PREPARED FOR THE PLAN COMMISSION

Project Address: 223 South Pinckney Street (District 4- Ald. Verveer)
Application Type: Demolition Permit, Planned Development Alteration, Conditional Use, and Certified Survey Map
Legistar File ID # [55916](#), [55921](#), [56121](#), & [56288](#)
Prepared By: Kevin Firchow, AICP, Planning Division
Report includes comments from other City agencies, as noted
Reviewed By: Heather Stouder, AICP, Planning Division Director

Proposal Summary: This request includes modifications to an approved 253-unit hotel and mixed use building to remove one underground level and associated onsite parking, with corresponding façade alterations. As part of this proposal, the applicant also requests re-approval of the conditional use for select projections above the Capitol Height Limit. The City Parking Utility also requests re-approval to demolish the Government East Parking Garage. Finally, a two-lot Certified Survey Map is proposed to divide the subject property into two lots.

Above: West Wilson Street - Lower Levels of Hotel
Proposed May 7, 2019 Alteration

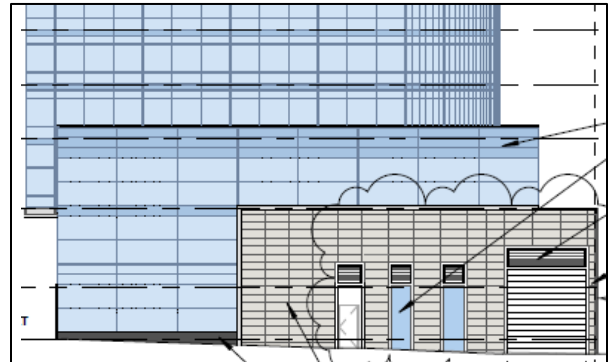
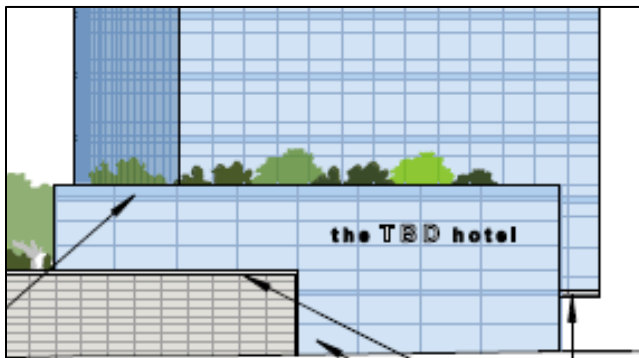
Corresponding façade changes are proposed to the East Wilson and Doty Street facades. Along Wilson Street, the previously approved underground parking entrance is now comprised of a door and spandrel-clad panels. Along Doty Street, additional windows and doors to an enclosed bike parking area are now proposed. No changes are proposed along South Pinckney Street.
